Transport Management and Accessibility Plan Addendum

Ivanhoe Estate Redevelopment, Macquarie Park (SSD 8707)

Ref: P0421r04v02
13/09/2018

Figure 2: Main Street / Lyonpark Road SIDRA Intersection Layout

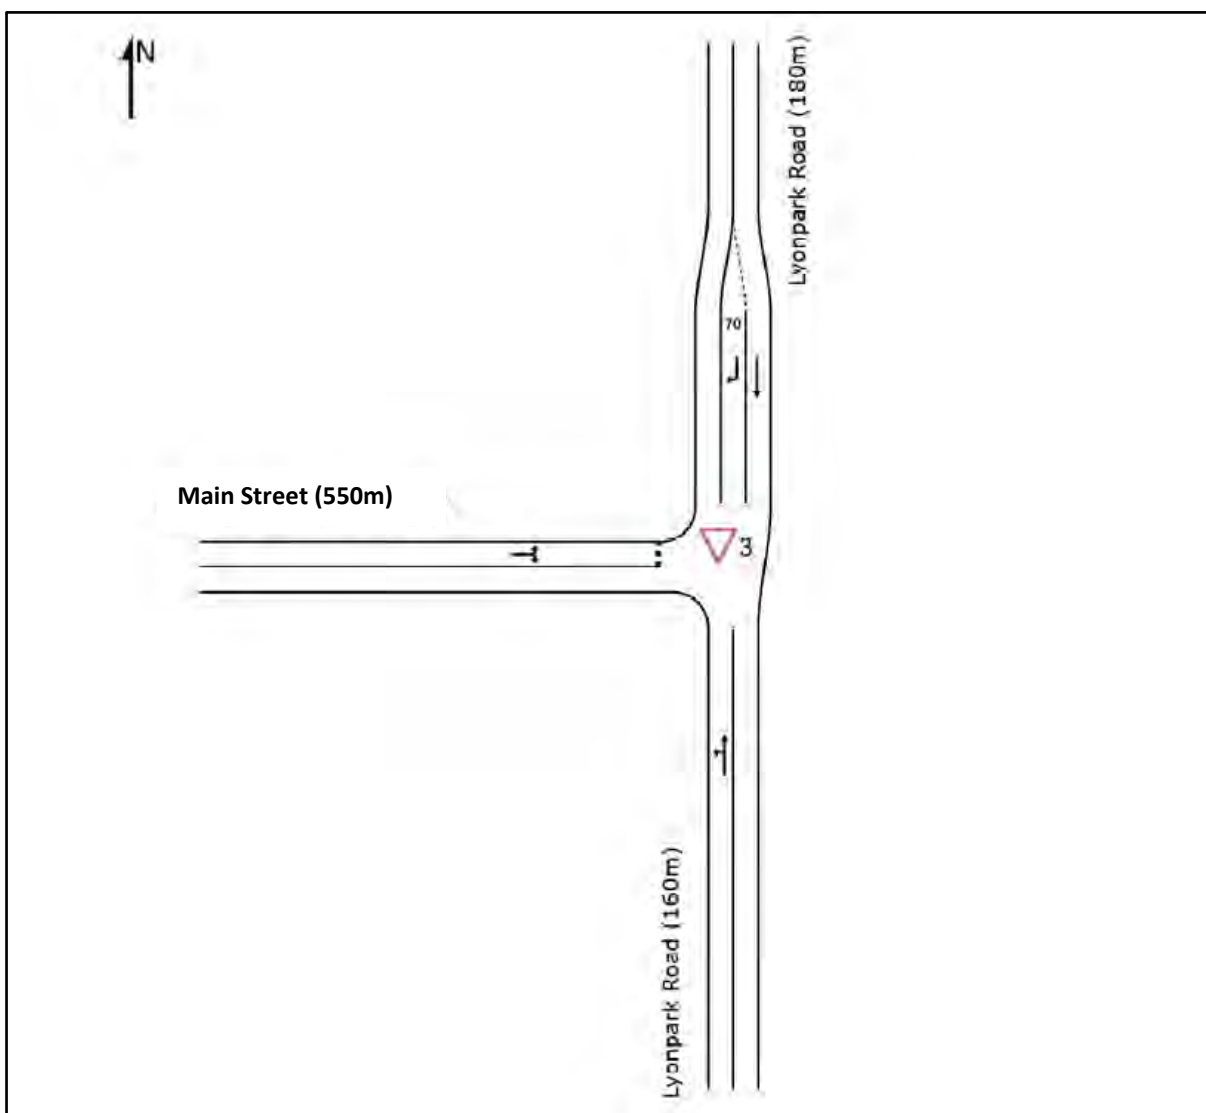
Further intersection modelling has been undertaken to assess the capacity of the Main Street and Lyonpark Road intersection during the AM and PM peak periods for the 2021 scenario. The existing priority controlled intersection performed acceptably in the 2021 scenario. However, the preferred layout option incorporates a 70m dedicated right turn bay into Main Street and has a separate southbound through lane. The results shown in **Table 5** demonstrate that the intersection continues to operate with a good level of service with the addition of the proposed development. The SIDRA outputs for this analysis are contained in **Appendix A**.

The future Lyonpark Road / Main Street intersection has been assessed and appropriate traffic control measures recommended given the volume of traffic this intersection is forecast to carry.

- Additional modelling of the intersection of Main Street with Lyonpark Road with the preferred layout option incorporating a 70m dedicated right turn bay into Main Street and a separate southbound through lane demonstrate that the intersection continues to operate with a good level of service with the addition of the proposed development.

Figure 3: Herring Road and Ivanhoe Place intersection

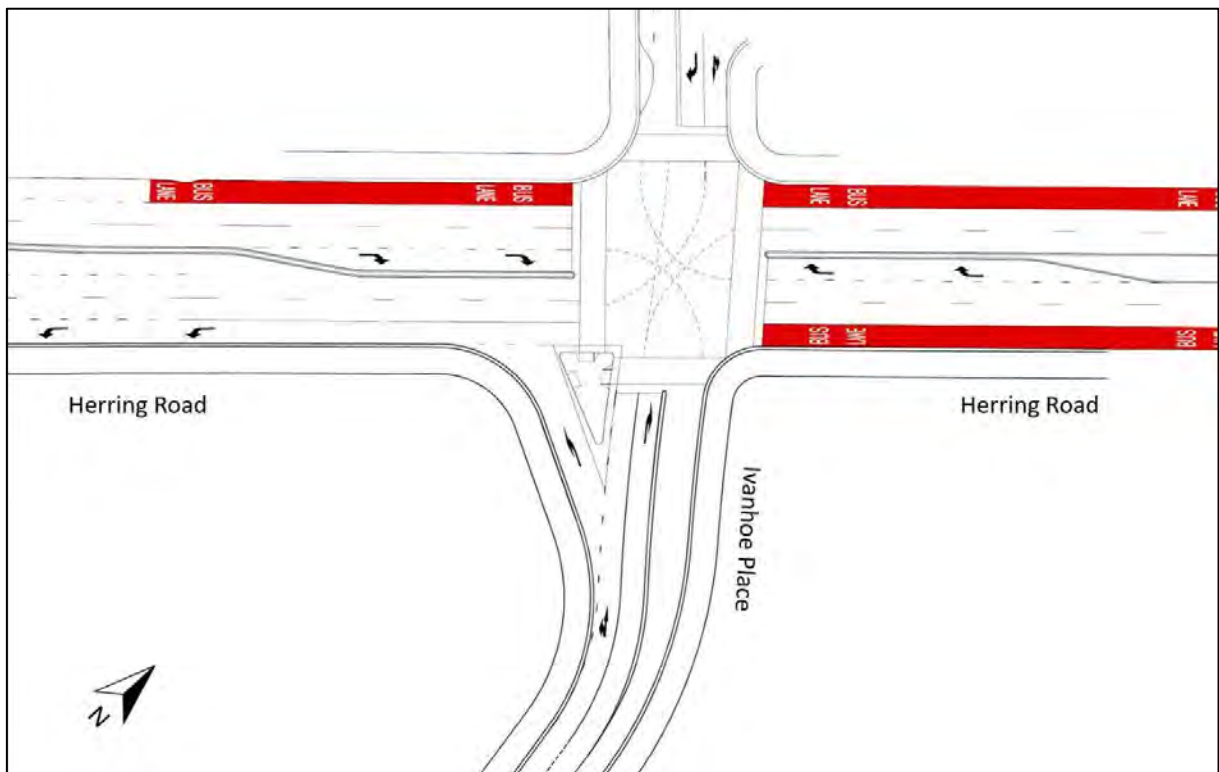
Following the issue of the Macquarie Park Bus Priority and Capacity Improvement Project Submissions (MPBPCI) report by RMS in October 2017 the reviewed layout and alignment of the proposed traffic signals at the intersection of Ivanhoe Place with Herring Road is illustrated in **Figure 3**. The intersection has been designed to facilitate double diamond phasing (as requested by RMS) and includes:

- a 44m right turn movement from Herring Road into Ivanhoe Place for northbound approach
- A left turn slip lane and dedicated right turn and through lane on the westbound approach within the Ivanhoe Estate,
- A 52m right turn lane for the southbound approach for vehicles turning into the Morling College, and
- A shared through / right turn lane and dedicated right turn lane for the eastbound approach.

The proposed intersection arrangements have been included in the future year models and provides the main access to the proposed development.

Figure 4: Proposed left-in access from Epping Road to the Site

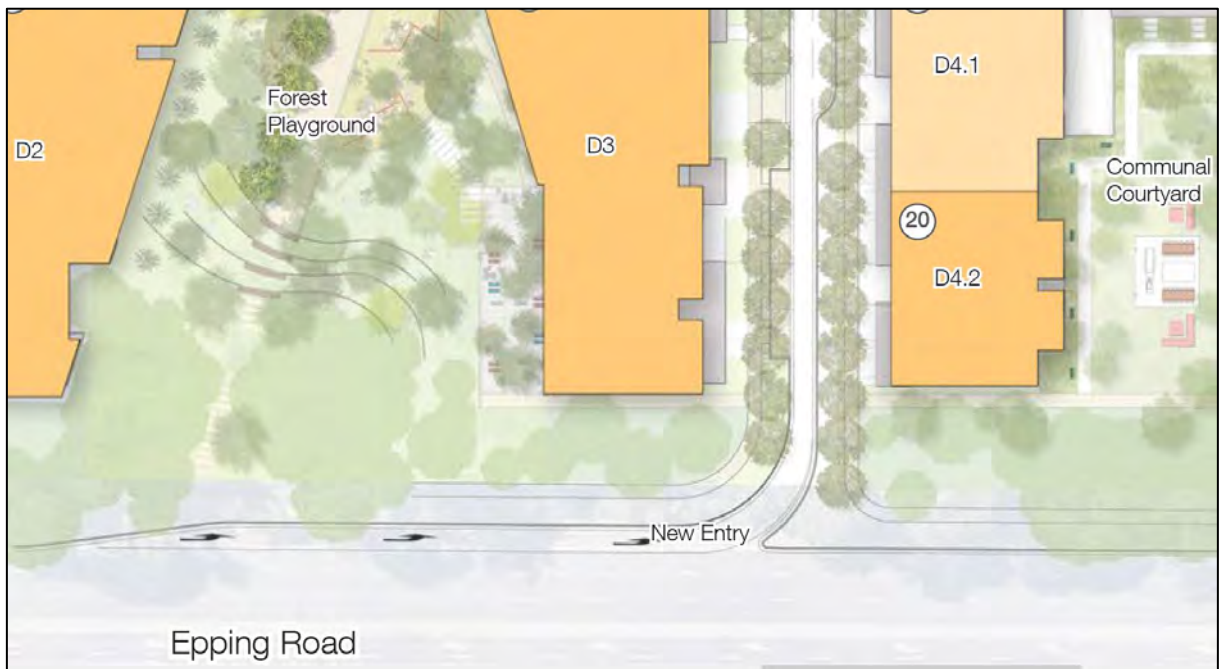
It is proposed that a new road connection from Epping Road be constructed approximately 300m east of the Herring Road with Epping Road intersection. The proposed access as shown on **Figure 4**, includes the construction of a new deceleration lane (to RMS requirements) and will provide access to the site without the need for vehicles to travel along Herring Road. This will provide reduced delays on Herring Road particularly during the evening peak hour.

Figure 9: Main Street Bus Bay Revision

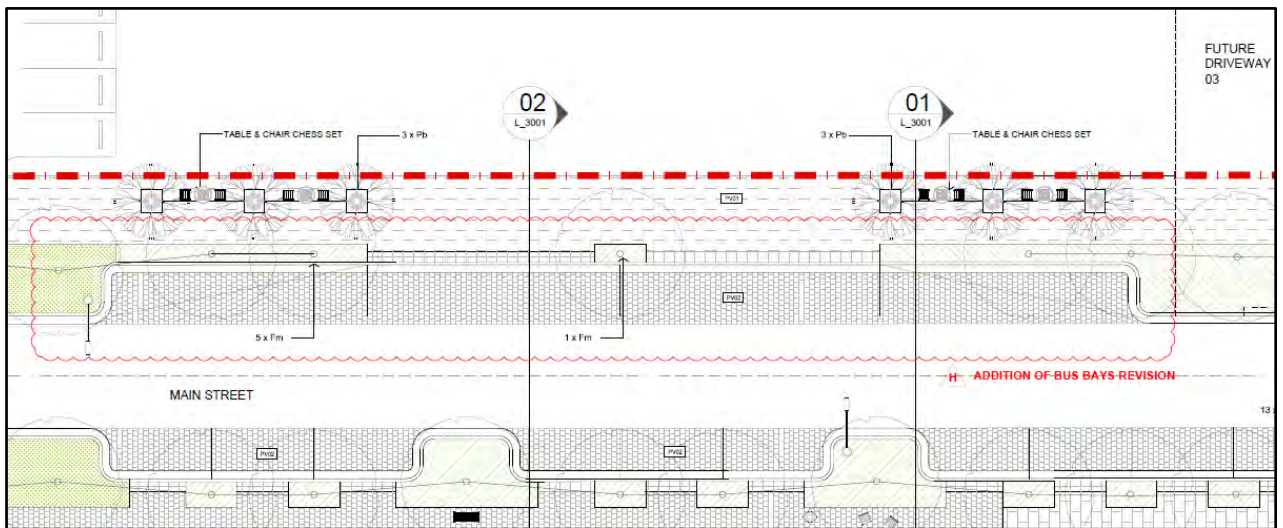
Main Street and the bridge connection to Lyonpark Road have been designed to accommodate 14.5m buses and meet the relevant standards. 60m of indented bays have also been provided on Main Street to accommodate a minimum of two 14.5m buses as shown in **Figure 9**.

The internal road network has been designed to accommodate the relevant requirements for buses

- The internal road network and bridge connection to Lyonpark Road have been designed to accommodate the relevant requirements for 14.5m buses including a minimum 3.5m travel lanes

and 3.0m wide bus parking bays. 60m of indented bays have also been provided on Main Street to accommodate a minimum of two 14.5m buses.
